## REVISED RESPONSE TO REQUEST FOR ADDITIONAL INFORMATION

### APR1400 Design Certification

Docket No. 52-046

RAI No.: 49-7825

Figure 06.02.01.05-1-1. Pressure Comparison between Current and Revised Containment input

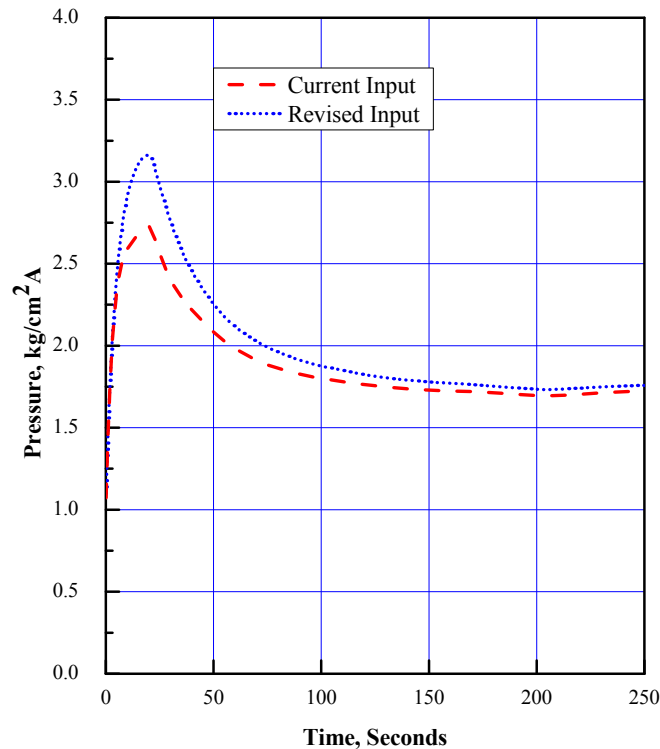
In Design Control Document (DCD) Tier 2, Section 6.2.1.5.4, the containment free volume used for the minimum pressure calculation is specified, and includes a “consideration of uncertainty.” In a response to the RAI, provide additional detail on the value of this uncertainty, including the magnitude and reasoning used to determine the value, and provide what degree of margin there is from the calculated value versus the expected asbuilt free volume. Update DCD Tier 2, Section 6.2.1.5.4 with the margin used in the minimum pressure calculation. The staff needs this information to assess the degree of conservatism in the analysis.

Figure 06.02.01.05-1-1 shows a comparison of the containment pressure using the current containment input against the revised input. The passive heat sink data of current containment input are constructed by merging 10 heat structures of conservative surface area and wall thickness. The 19 heat structures are modeled with the direct reflection of the revised containment input design data. (See markup in Attachment 1)

Figure 6.2.1-48 ECCS Performance Analysis (Cooling Fan Heat Removal Capacity)

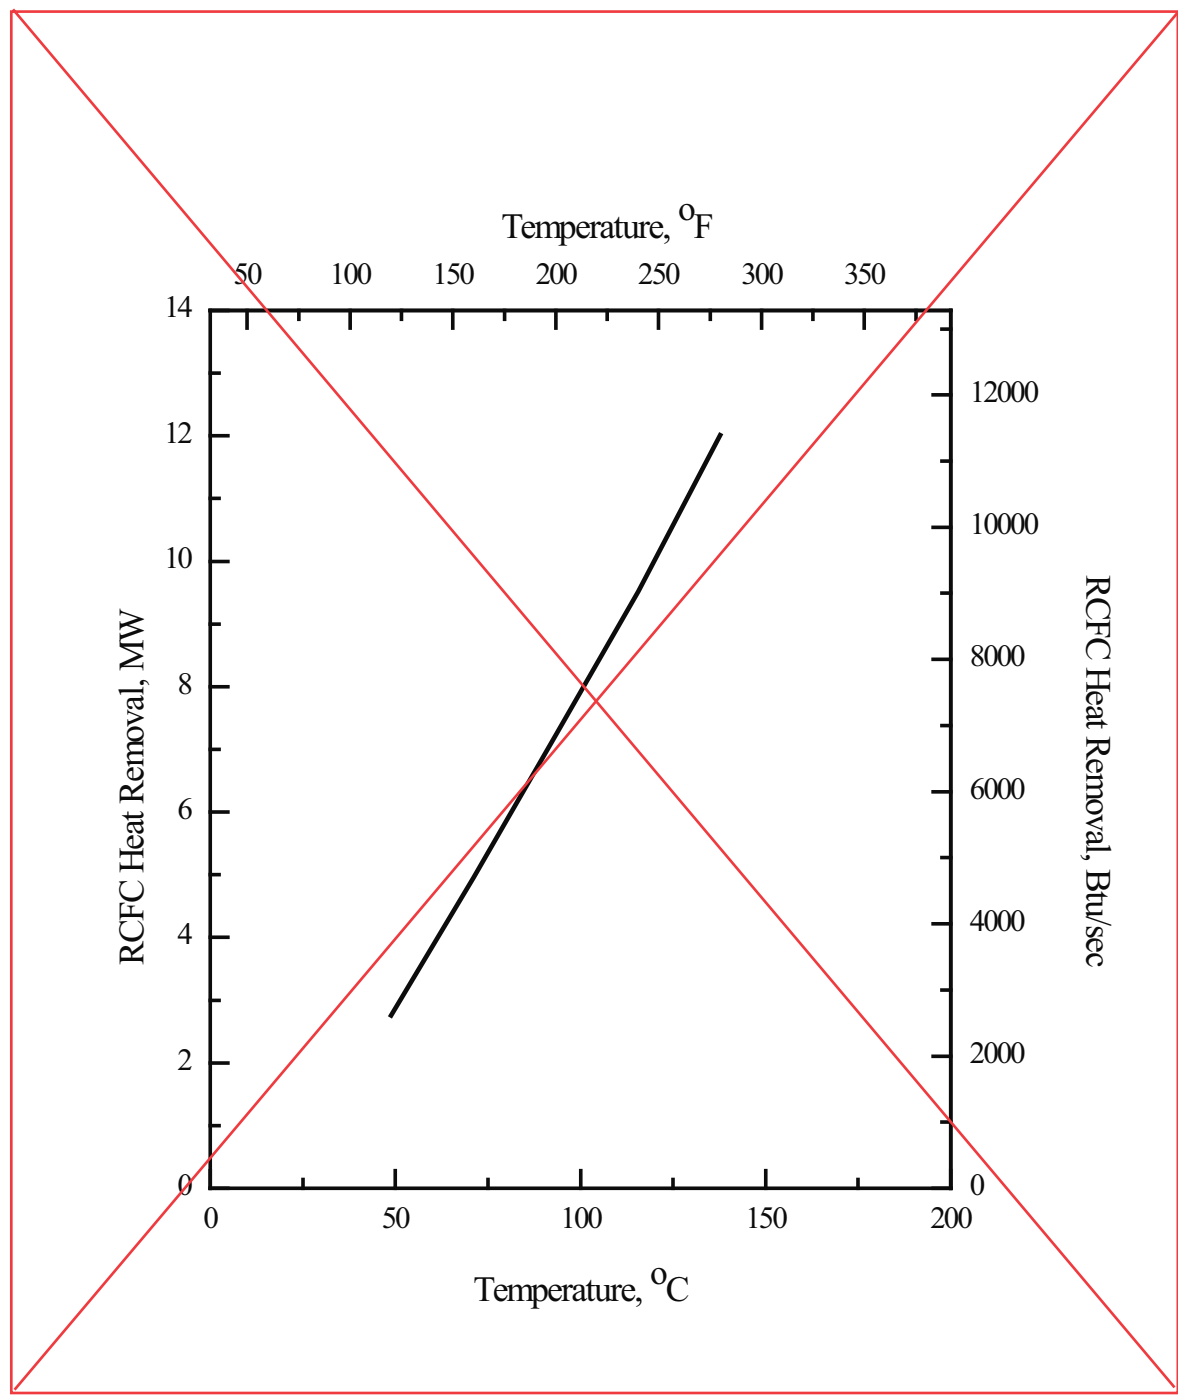
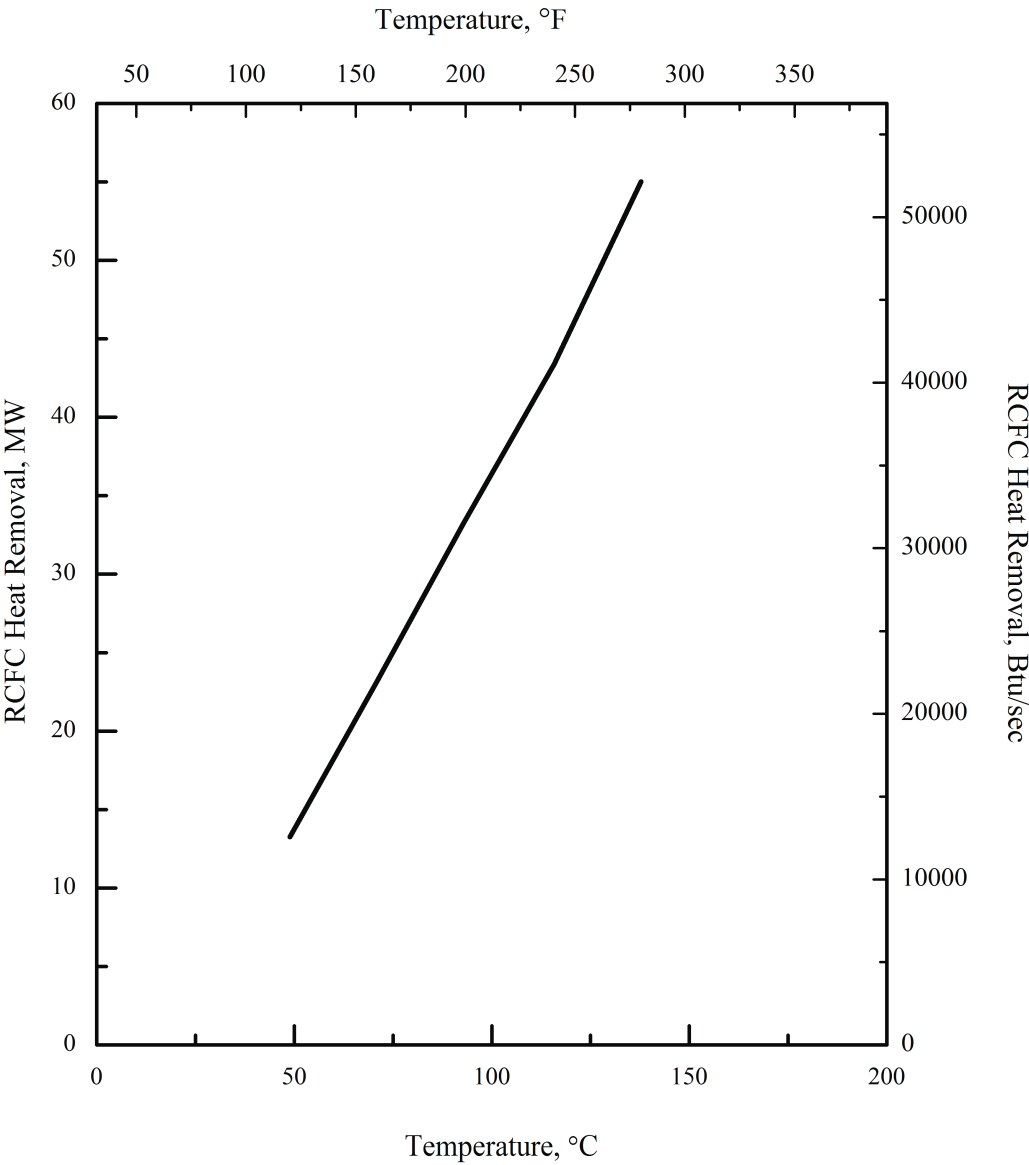
The re-analyses of the LBLOCA have been performed. Tables 6.2.1-23 and 6.2.1-24 are revised to incorporate the updated information. Table 6.2.1-39 and Figures 6.2.1-48, 49, 50, 51 and 52 are also revised.

Replace with next page H
